To: Development Permit Panel
From: Brian J. Jackson, MCIP
Director of Development
Date: July 6, 2010
File: DP 10-520511
Re: **Application by Onni Group of Companies for a Development Permit at 6951
Elmbridge Way**

Staff Report

ADJACENT SITE

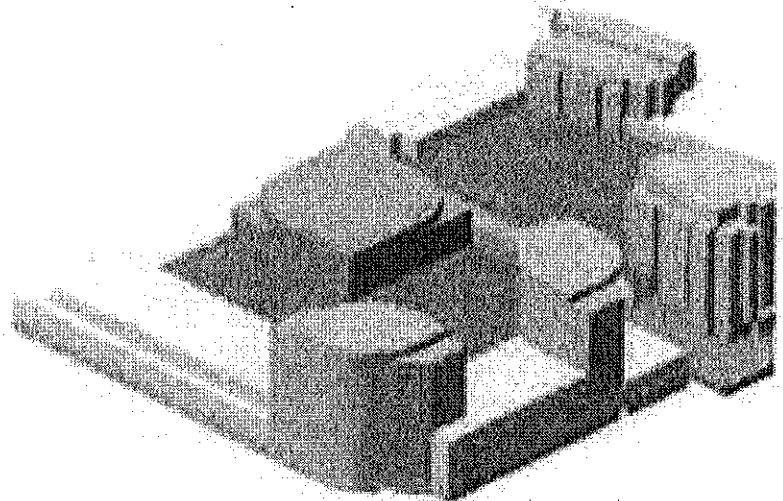
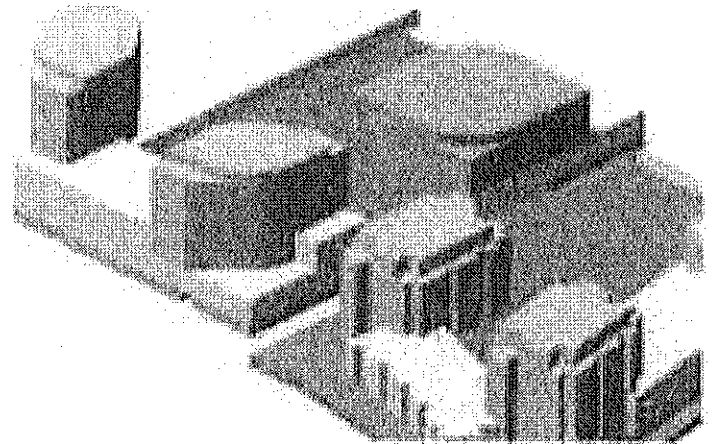
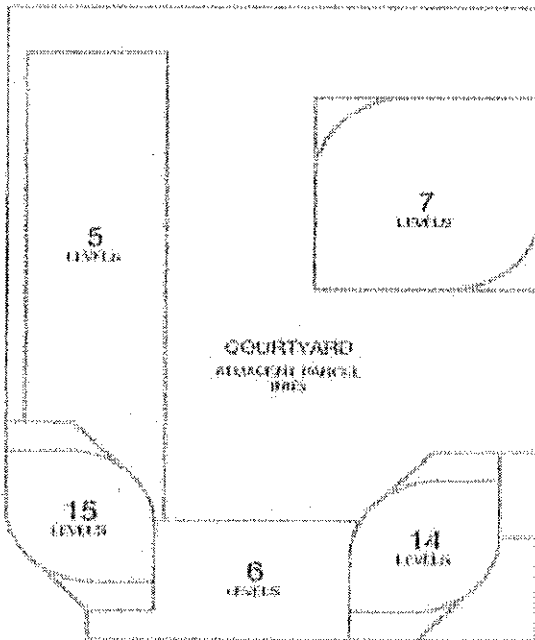
- d) Continuous handicapped access, weather protection, seating, and other pedestrian amenities.
 - West: Along the development's interior side yard, a public lane is proposed to provide for 100% of the subject development's vehicle and service access, along with access to future development to its west. The neighbouring site, like the subject site, is designated for high-density, high-rise, mixed-use development. The developer has submitted an illustrative development concept for the neighbouring site, to the satisfaction of staff, demonstrating a density of 3 FAR, including 2 FAR of residential uses in two towers, a mid-rise office tower, and a mix of retail and residential at grade. (**Attachment 4**)

Hollybridge Way – Locations of Possible Road Right-of-Way Encroachments (as per SA 10-534017)

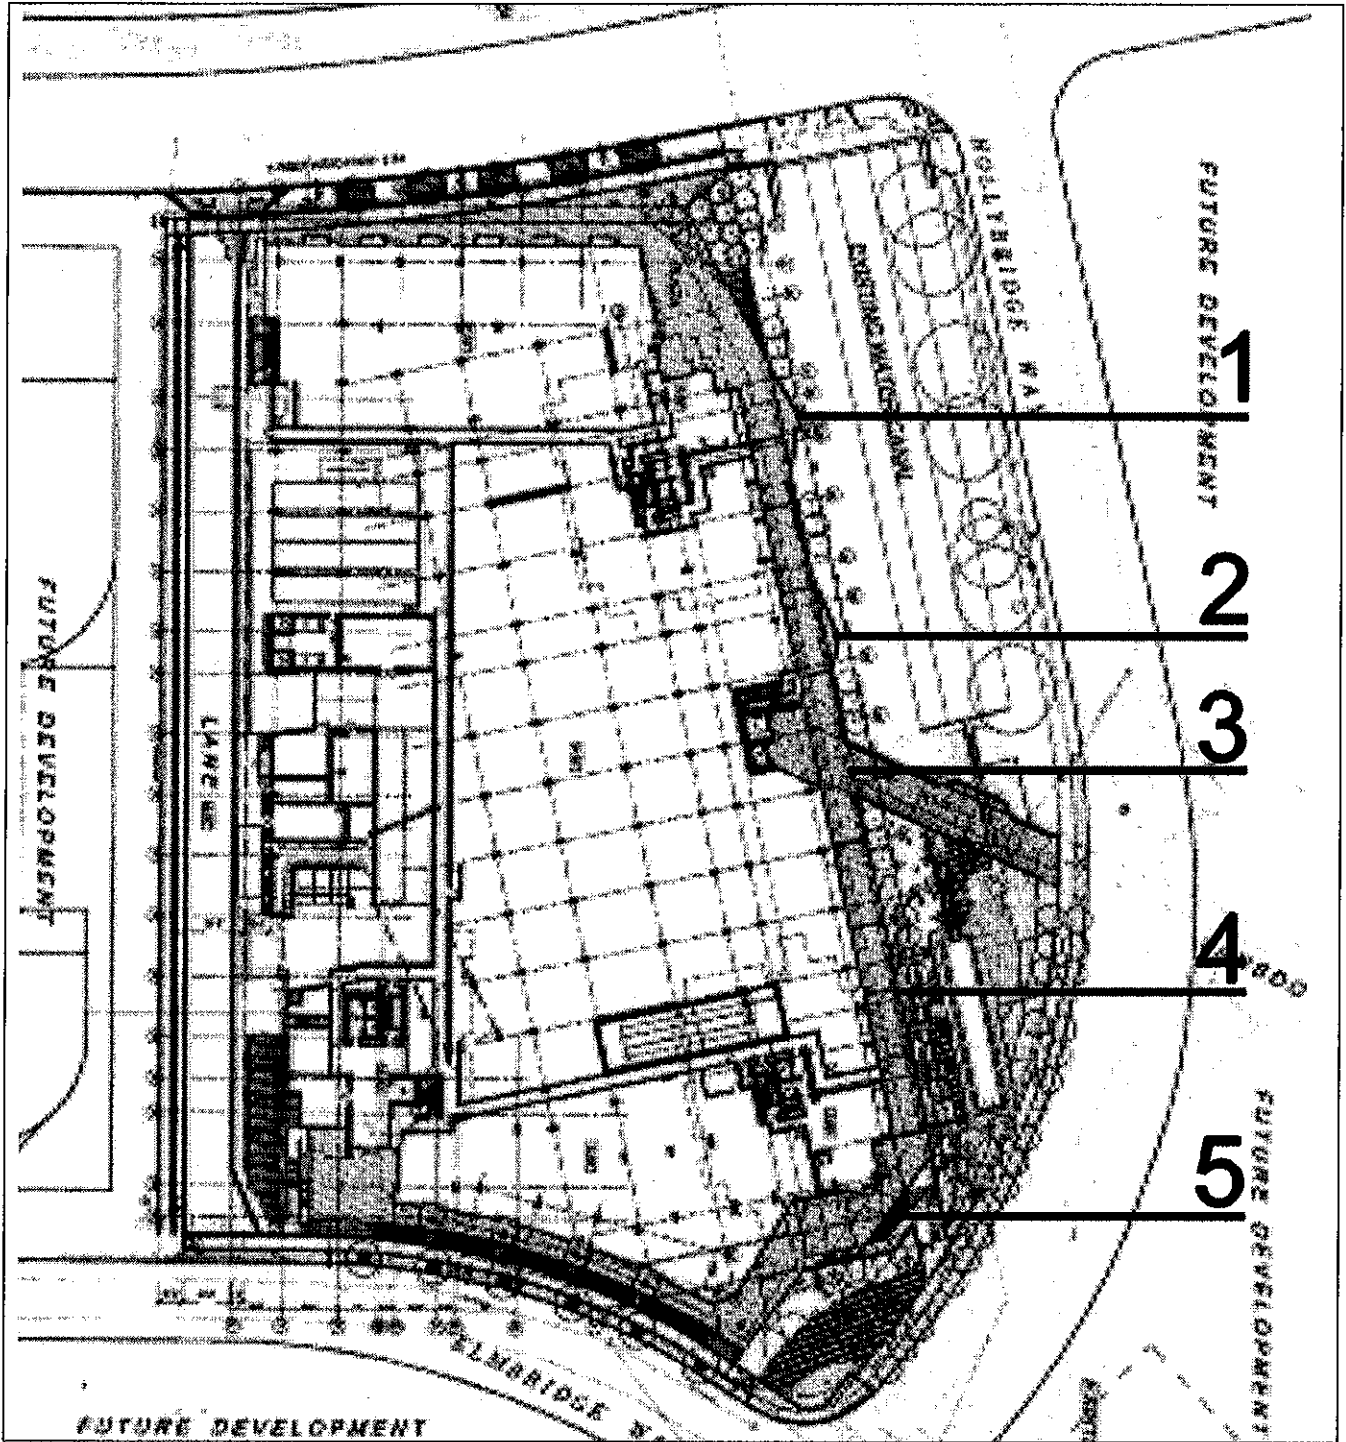
- Potential Road Right-of-Way Encroachments: Via SA 10-534017 for the developer's design and construction of the Hollybridge Canal Park, staff have identified a number of features (e.g., stairs, ramp, bridge) that must be linked "seamlessly" with the subject development. To achieve this, it may be necessary to physically tie one or more of these park features to the proposed building, and in doing so, some portion(s) of the building's proposed Hollybridge walkway may be required to encroach into the park (i.e. Hollybridge Way road right-of-way). Staff are supportive of any such encroachments, the possible locations of which are shown in **Attachment 5**.
